ADDENDUM 01BID No. B-01-2020-21

SIERRAMONT MIDDLE SCHOOL ORNAMENTAL FENCES AND GATES PROJECT

Berryessa Union School District

October 19, 2020

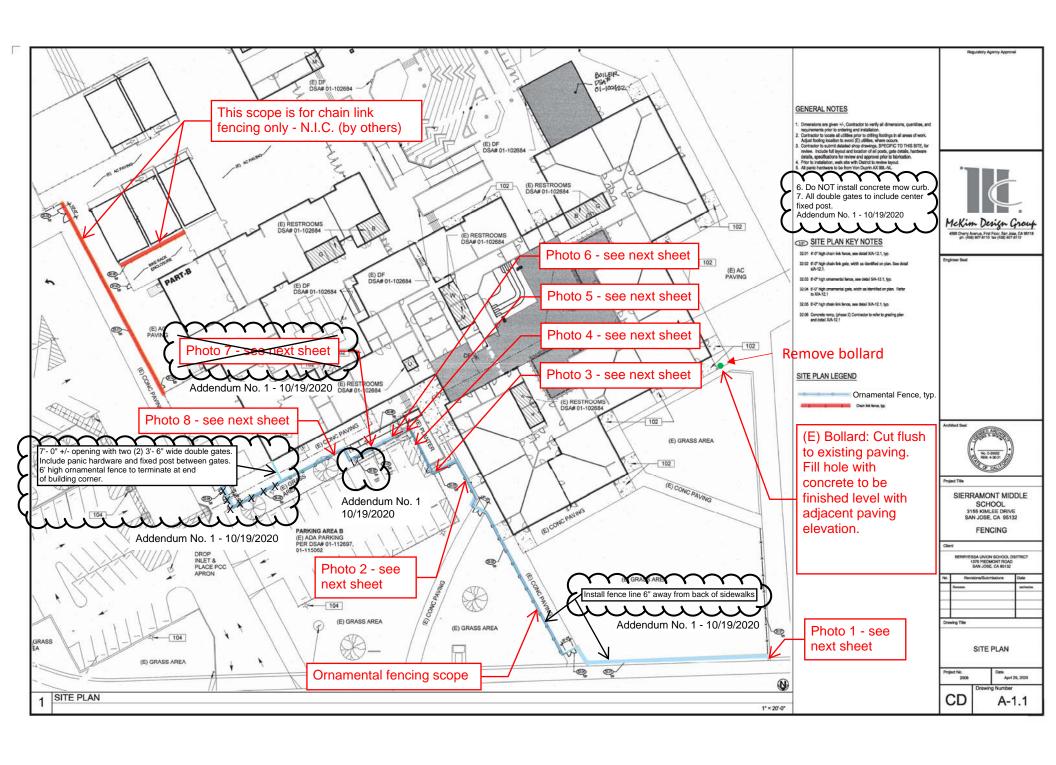
Item 1: Sheet A-1.1

Added general note 6 to read "Do NOT install concrete mow curb".

Item 2: Sheet A-1.1

Added general note 7 to read "All double gates to include center fixed post".

Item 3: Sheet A-1.1

Removed "Photo 7 – see next sheet" call out.

Item 4: Sheet A-1.1

Added call out to read "7'- 0" +/- opening with two (2) 3'- 6" wide double gates. Include panic hardware and fixed post between gates.

6' high ornamental fence to terminate at end of building corner."

Item 5: Sheet A-1.1

Removed portion of fence so that fence terminates at end of building corner.

Item 6: Sheet A-1.1

Revised gate opening and sizes.

Item 7: Sheet A-1.1

Revised gate swing to swing towards parking lot (away from building).

Item 8: Sheet A-1.1

Added note "Install fence line 6" away from back of sidewalks.

BUSD – SIERRAMONT MIDDLE SCHOOL ORNAMENTAL FENCES AND GATES PROJECT PHOTO REFERENCES TO SHEET A-1.1

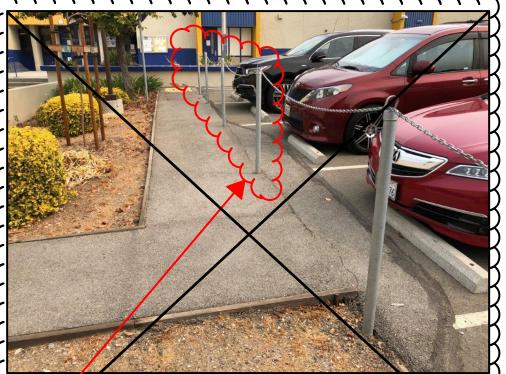
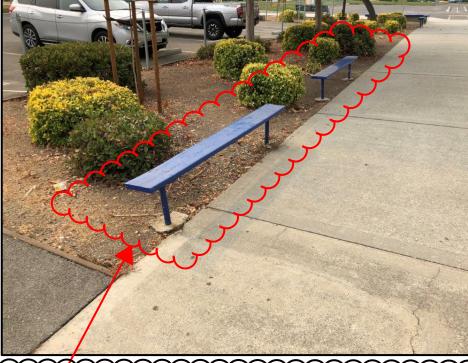
Item 9: Photo References Sheet (sheet 2 of 3)

Removed Photo #7 from Photo References sheet 2 of 3.

Item 10: Photo References Sheet (sheet 2 of 3)

Revised second Photo #7 reference to Photo #8 to read "Photo 8: Quantity two (2) existing benches to be removed. Remove concrete footings and backfill.

Photo 8: Quantity two (2) existing benches to be removed. Remove concrete footings and backfill.
